# 1ST & PIKE

103 PIKE STREET

EARLY DESIGN GUIDANCE 3  
03 APRIL 2018  
DPD #3028428

1. ARCHITECTURAL CONTEXT - SHADOW STUDIES - WINTER

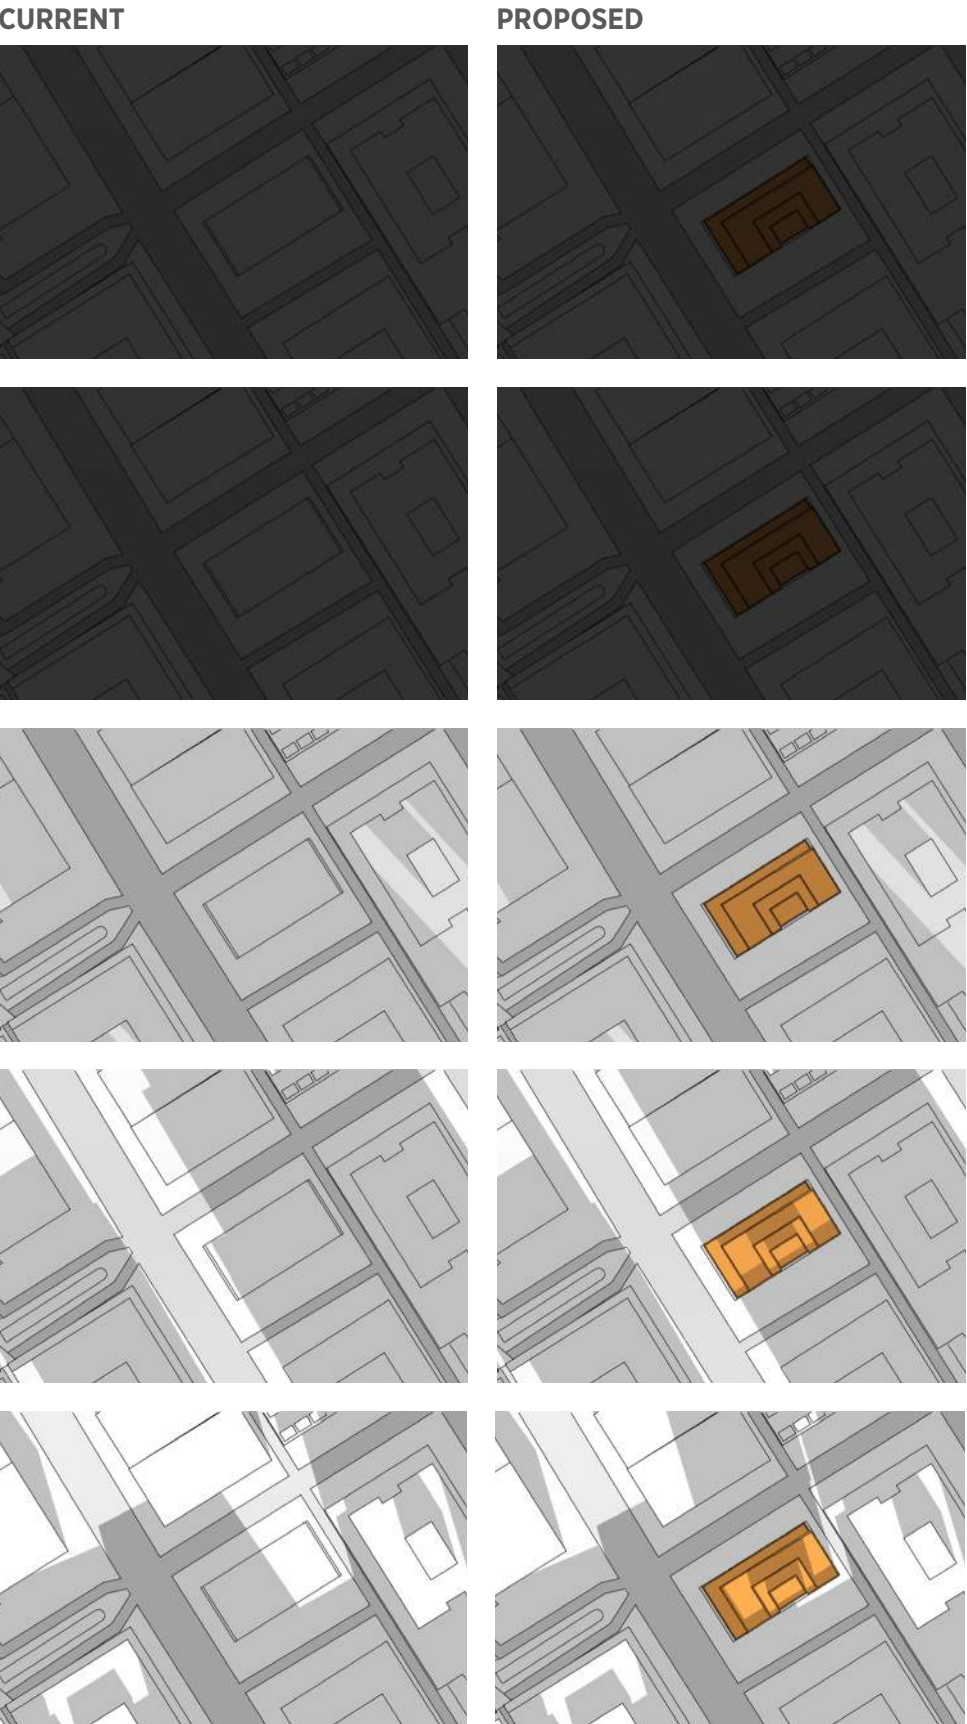
1.a.ii The Board requested an enhanced solar/shade study be provided and presented at the next EDG meeting , including information (early morning times) illustrating if and how long the design would cast shadow onto the Pike Place Market. The study should also differentiate between the existing shadow condition and forecasted shadow condition with the design's massing.

The team performed a solar/shadow study to understand the design's impact on the surrounding context. The analysis showed minimal shadows would be cast on the corner of Pike Place Market between 7-9 a.m. during the Spring and Fall Equinoxes. A small shadow would be cast on the sidewalk in front of the Corner Market building between 8-9 a.m. at Summer Solstice. Existing buildings are the primary contributors to the morning shadow. Times when there is a shadow cast have been highlighted in orange.

# 1. ARCHITECTURAL CONTEXT - PIKE STREET RENAISSANCE

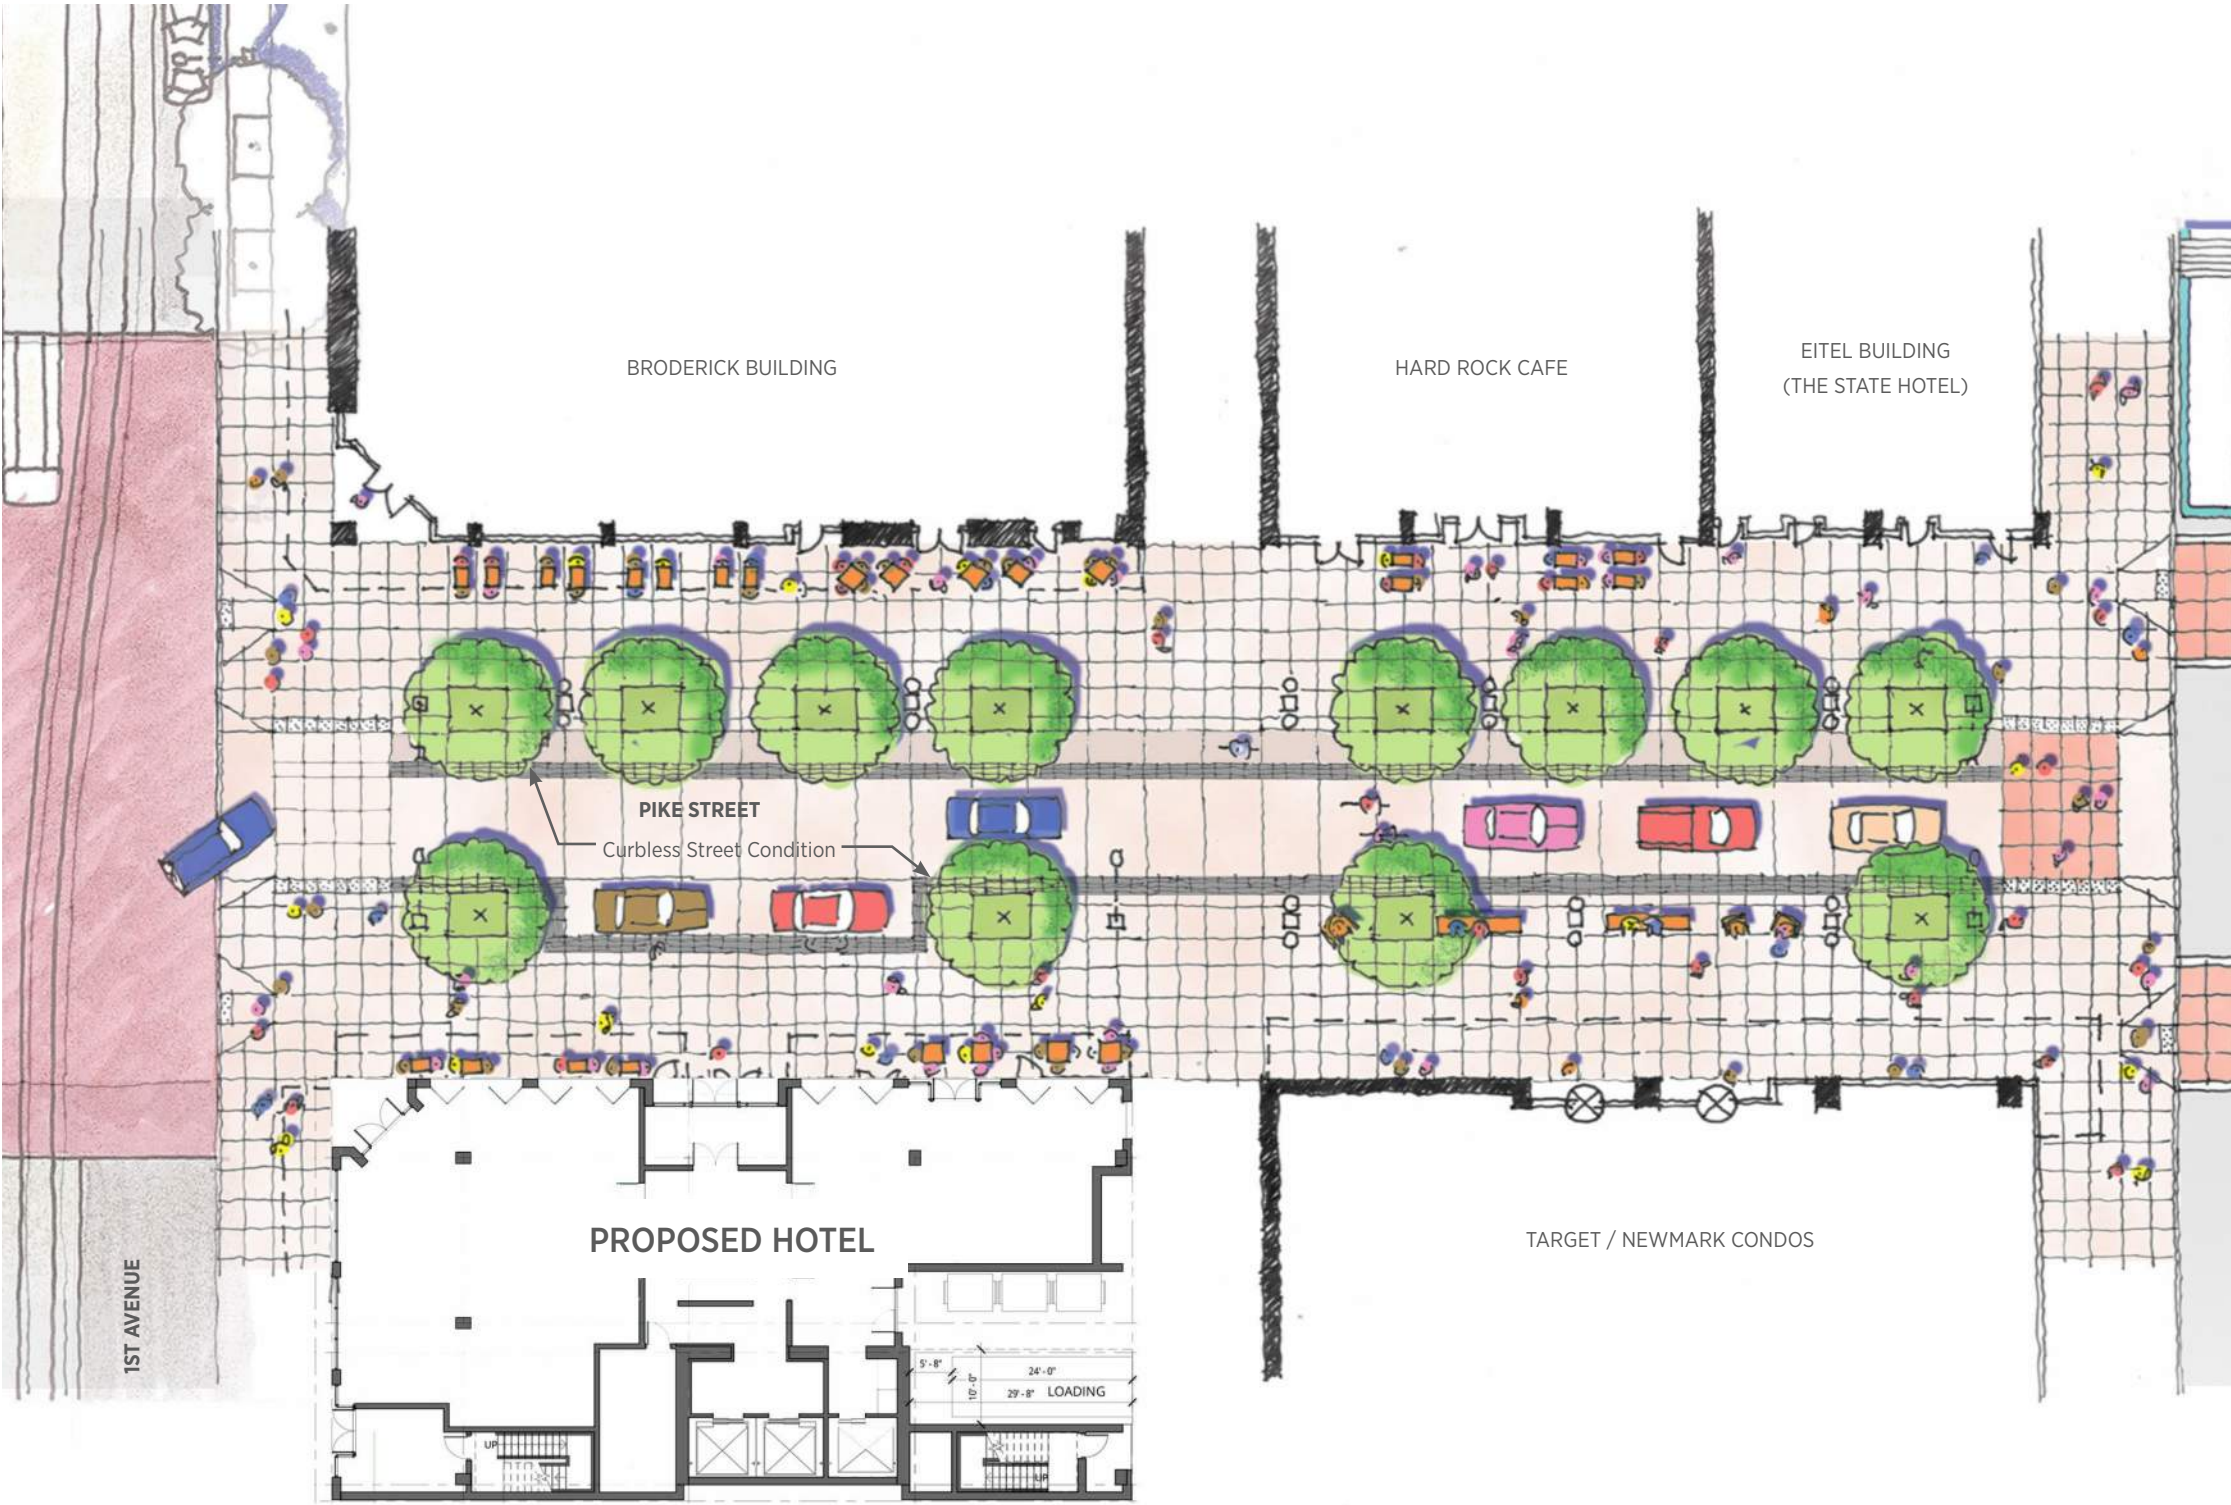
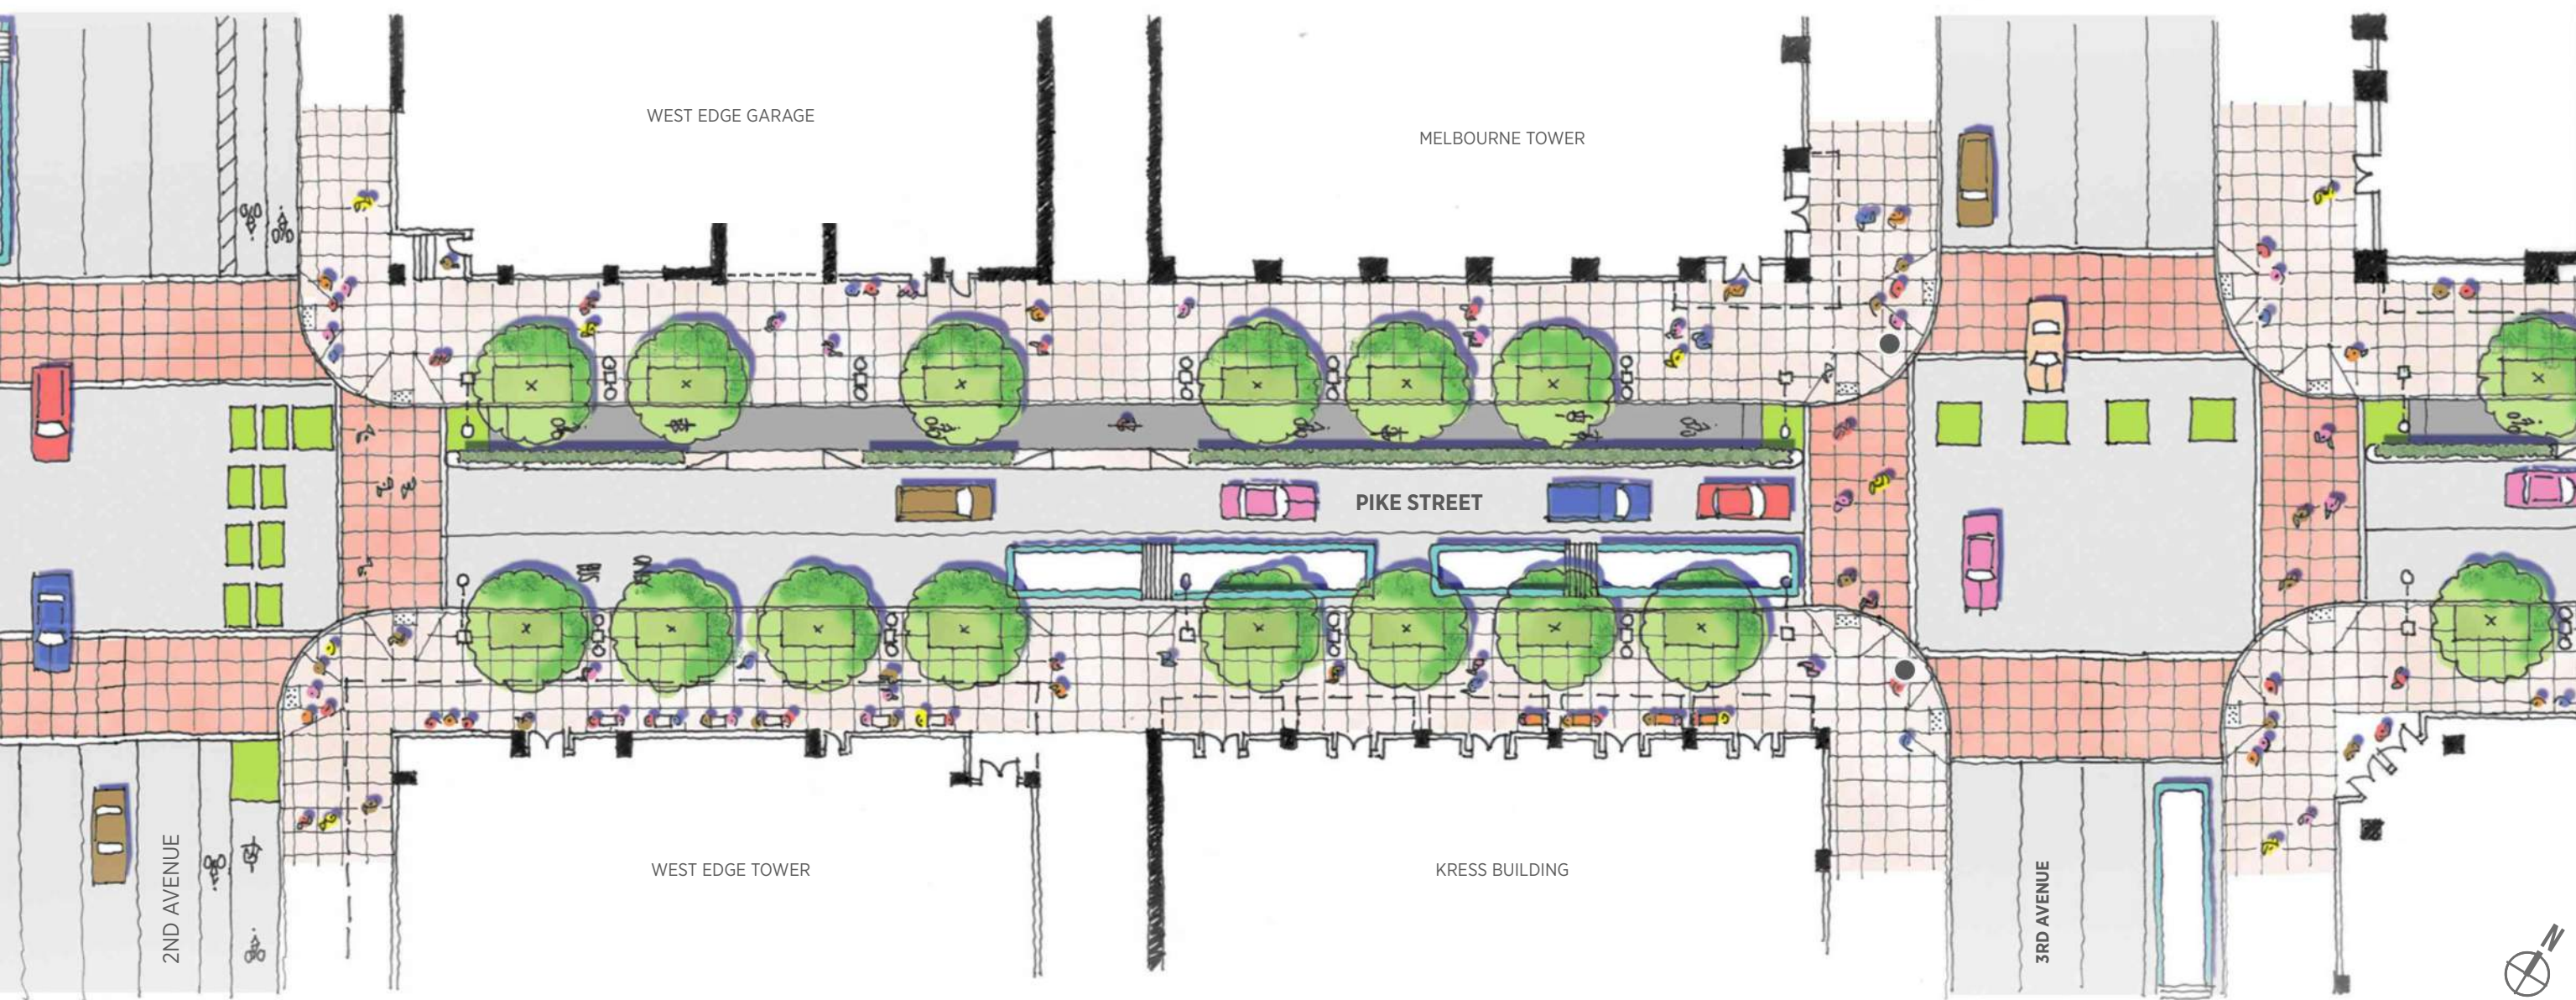
1.a.ii Provide updated information on the proposed street improvements (curb configuration, street trees, etc.) along Pike Street. The Board understands that planned improvements to both 1st Avenue and Pike Street are evolving and under the purview of the Seattle Department of Transportation (SDOT).

The design team is actively following development of the Pike Pine Renaissance Plan and the Center City Connector Streetcar along First Avenue. The team has met with members of various SDOT departments and will continue an on-going dialogue as the project progresses.

## 1. PODIUM

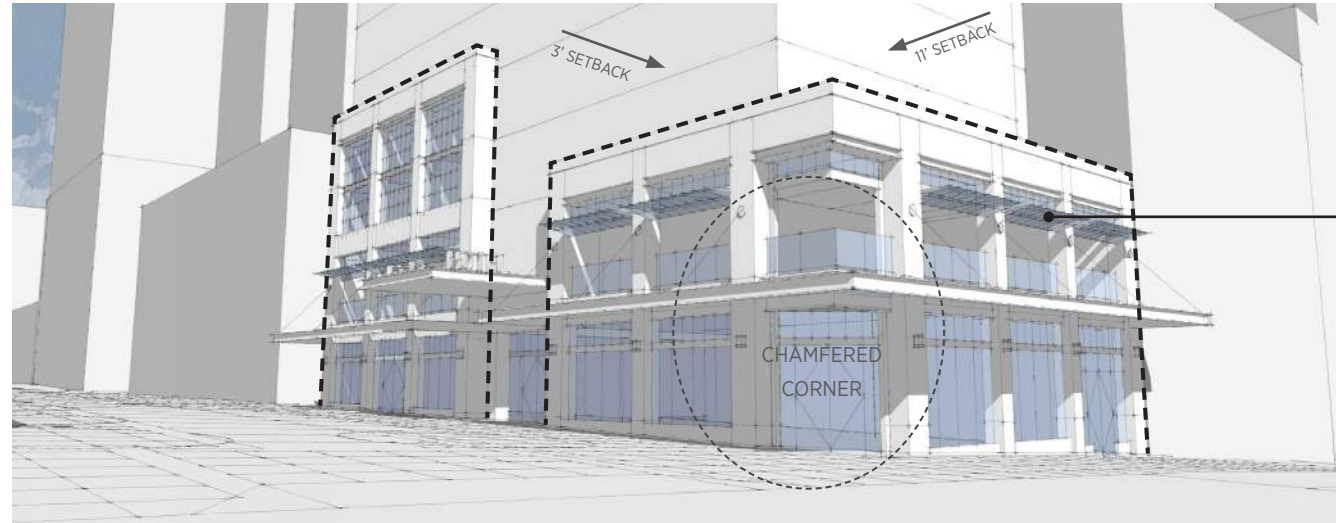
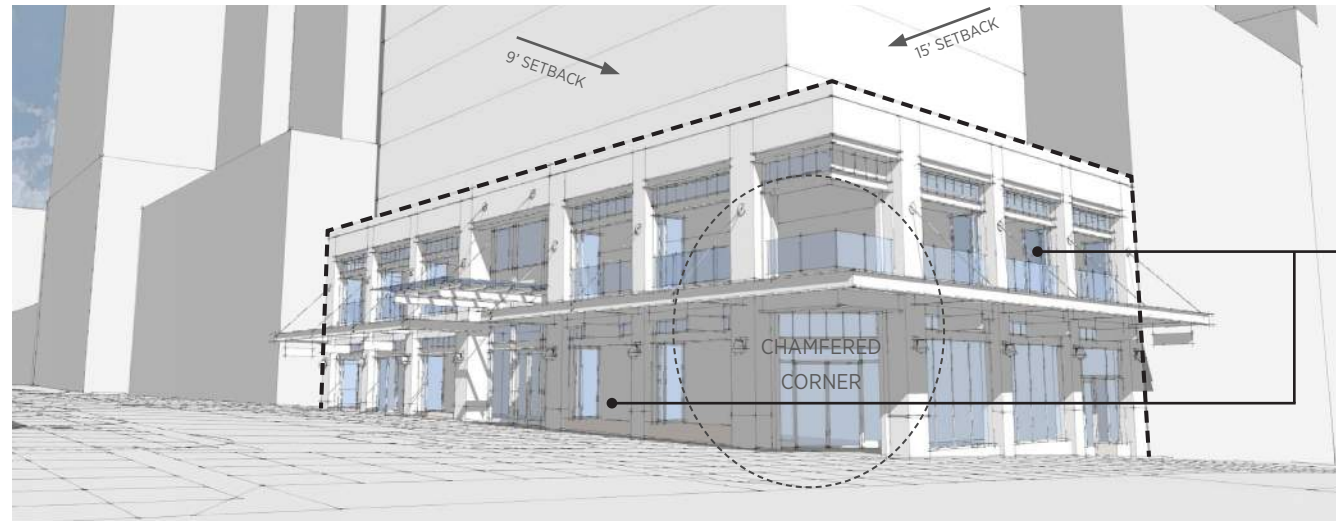
1.a.iii The Board's comments pertaining to the structure's podium were as follows:

- The Board reiterated strong support for a two-story podium/base. The Board's response to the splitting and stepping of the revised base to relate to the Newmark podium was not supported. The Board stated that it is imperative that the podium reads as an independent block and a mass and not as an applied facade. The Board requested that a consistent two-story podium base be considered and studied.
- The Board's response to the proposed second story fenestration (operable, active facade) were very positive.
- The Board supported the chamfered corner entry but had concerns about the placement and frequency of the entries. The Board emphasized that the retail entries should mimic the streetscape characteristics of the Market (open, engaging, multiple entries, etc.) and the features currently shown on the design's second story for context.

- The revised design maintains a distinct two-story base in order to relate to the scale of the intersection's existing structures.
- Operable windows (tenant option) have been added to the ground level to activate the facade and reflect the open facades found throughout the Market.
